**INSPECTION OF HABIB RAHMAN SECONDARY SCHOOL
CONSTRUCTION PROJECT IN KAPISA PROVINCE:
DESIGN AND SAFETY ISSUES REQUIRE ATTENTION**

SUBJECT: SIGAR Inspection Report 10-3: Inspection of Habib Rahman Secondary School
Construction Project in Kapisa Province: Design and Safety Issues Require Attention

Summary of Report: SIGAR Inspection 10-3

Figure 2: Design Plan for the Habib Rahman Secondary School which builds around a previously built, unfinished structure (shaded in yellow) rather than demolishing it. (Illustration provided by Kapisa PRT)

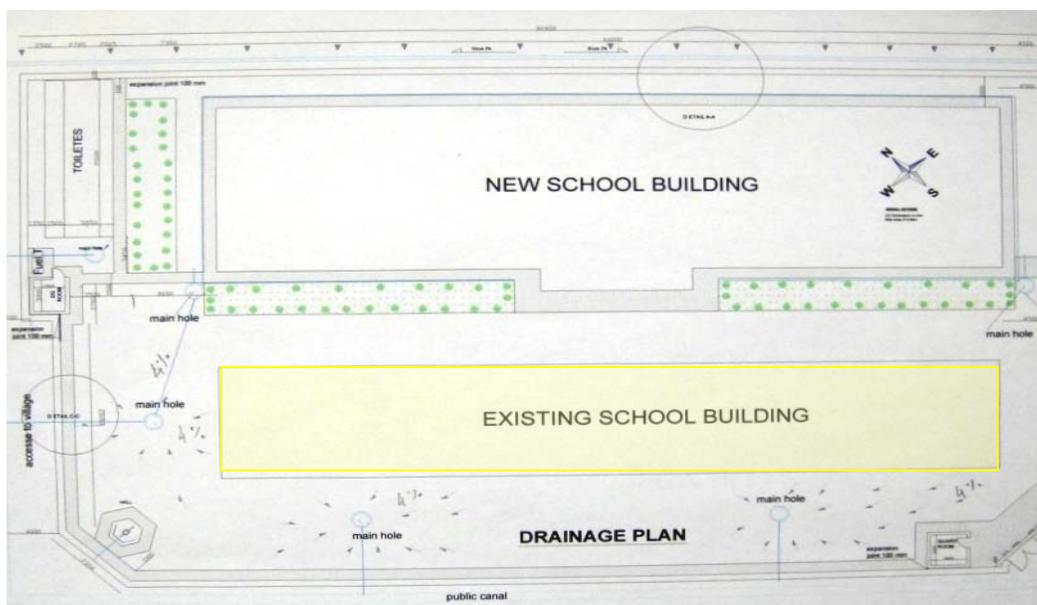
The first design flaw in the project noted by SIGAR focuses on the existence of a previously constructed but unfinished and unsafe structure (see Site Photo 2 and Figure 2) which occupies valuable land that could be used for a number of other purposes.³ When the Kapisa PRT became involved in the school project in the summer of 2008 following discussions with the Provincial Director of Education, it was decided that the existing structure should not be used because of concerns regarding its structural soundness. The current contract did not require the removal of this prior construction and PRT officials noted that they do not have plans to remedy this problem. SIGAR could not determine why this unfinished and unsafe structure was not demolished as part of the initial project proposal except for statements from the current PRT staff which indicated that local authorities believed they could make use of the unfinished structure. Despite attempts to

RECOMMENDATION 1: SIGAR recommends that the Commander, U.S. Forces-Afghanistan and Commander, Kapisa PRT initiate a follow-on CERP project to correct the design deficiencies noted in this report to include demolishing the previously built but unusable structure on the school compound, and constructing a protective retaining wall at the rear of the new school in place of the perimeter wall. (page 6 of SIGAR report)

KP PRT RESPONSE: Kapisa PRT partially concurs with information provided in this SIGAR Report. A follow-on project should be implemented for correcting the rear security wall and potentially adding a retaining wall and proper drainage. The reinforced concrete frame of the previously built school was left on site at the request of Nijrab government officials and local shura leaders. The engineers of the area are working to get funding to build a small community center and/or library on the site that may use some of the existing structure.
